## DESIGN COMMISSION REGULAR MEETING AGENDA

# Design Commission Design Review

<b>Project No:</b>	DSR18-004
<b>Brief Description:</b>	Study Session
<b>Location:</b>	2856 80 <sup>th</sup> Ave SE Mercer Island WA 98040; Identified by King County Tax Parcel #5452300540
<b>Applicant:</b>	Scot Carr, PUBLIC47 Architects
<b>Staff Contact:</b>	Robin Proebsting, Senior Planner

Mercer Island Design Commission Study Session  
November 14, 2018

## 77th Ave SE Existing Streetscape:

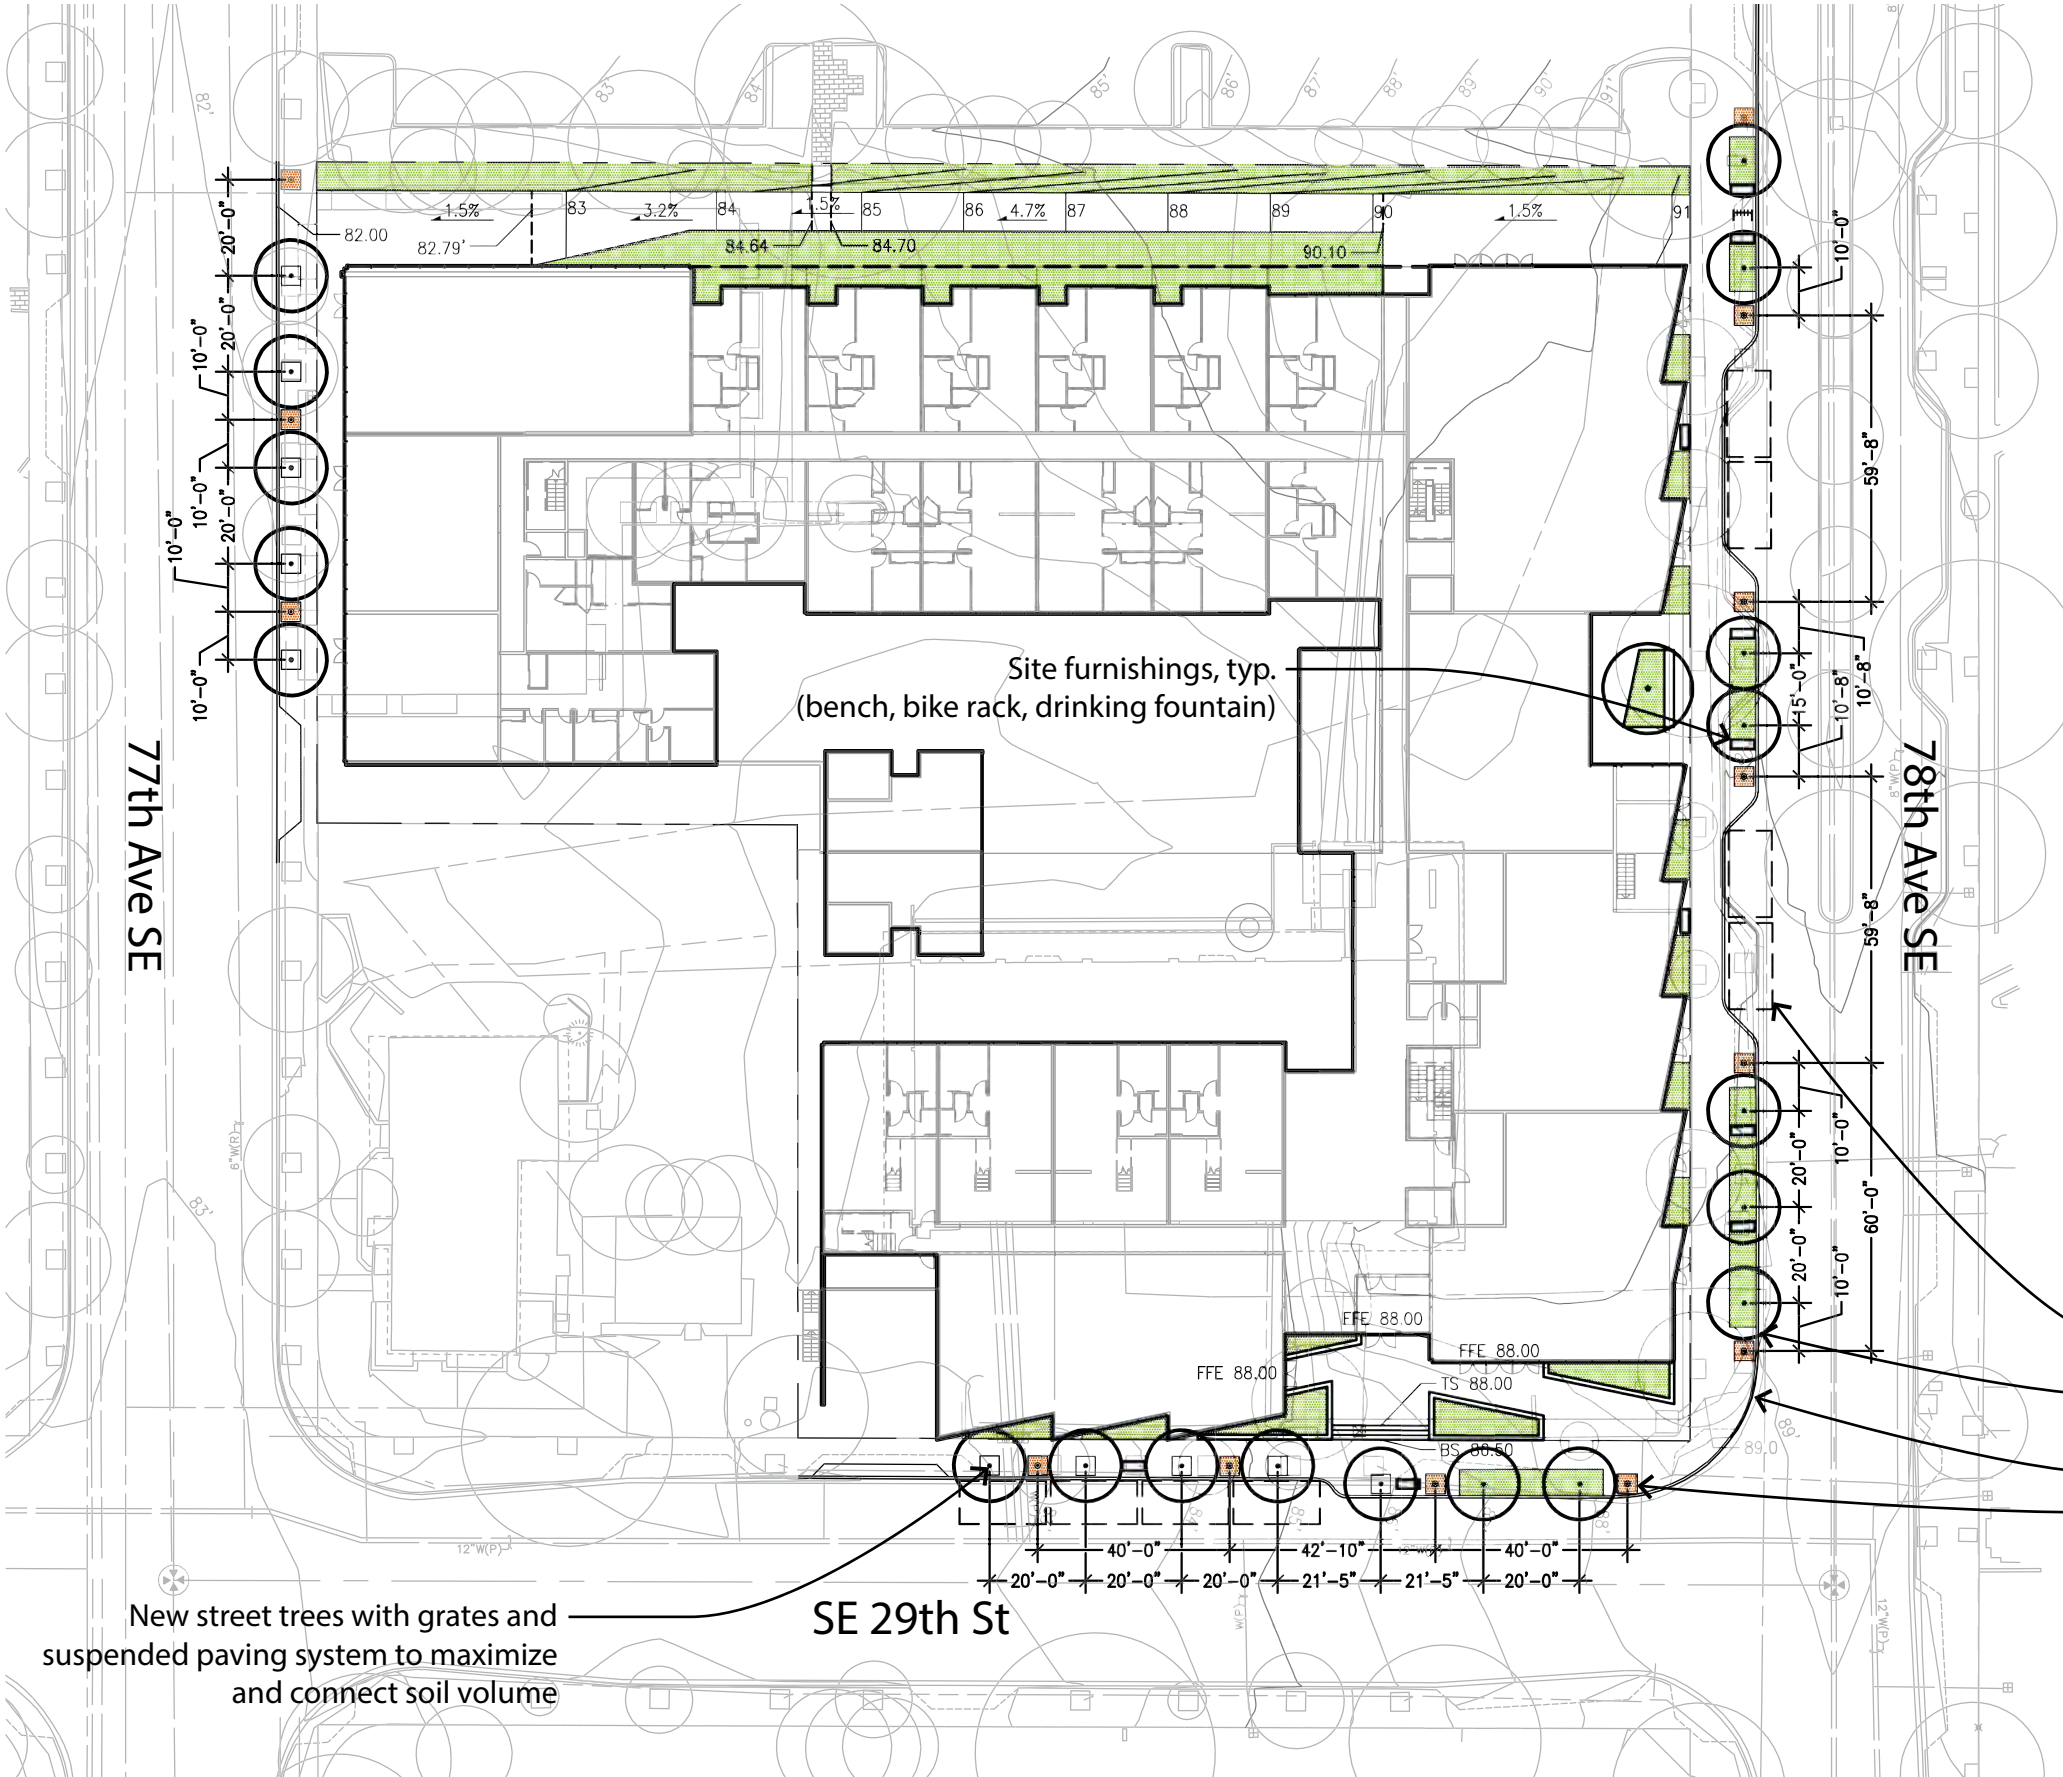
One of the applicant’s specific questions is about removing street trees in the right-of-way along 78th Avenue SE. MICC 19.11.120 requires street frontages along 77<sup>th</sup> Avenue and 78<sup>th</sup> Avenue to be improved as required in Figure 14 of MICC 19.11. MICC 19.11.120 allows the design commission to grant a modification to the nature or extent of any required street

improvements for 4 reasons. One of the reasons that could apply at this site would be reason(D) which states “If other unusual circumstances preclude the construction of the improvements as required.” Staff does not know of any unusual circumstances at the applicant’s site. To reconfigure the street frontage along 78th Avenue, the applicant is proposing to remove the street trees, and replant trees in a suitable number and type per the city arborists requirements. The trees are located at the back of the sidewalk which is not in conformance with Figure 14 because the trees separate pedestrians from the buildings, rather than separating traffic from pedestrians. The trees are outgrowing their tree grates and are becoming girdled by the grates. The city arborist has stated that the maples along 78th are not the best suited species to the site. The city arborist has stated that he will probably recommend removal. MICC 19.11.070(B)(2)(b)(i) states” “Prominent trees should be preserved to the fullest extent”. This is the only code section to the Town Center standards that addresses tree retention.

***If the arborist recommends removal of the trees, and the trees are replanted according to the city’s Streetscape Manual using city approved tree species, would the commission be ok with removal of the existing street trees?***
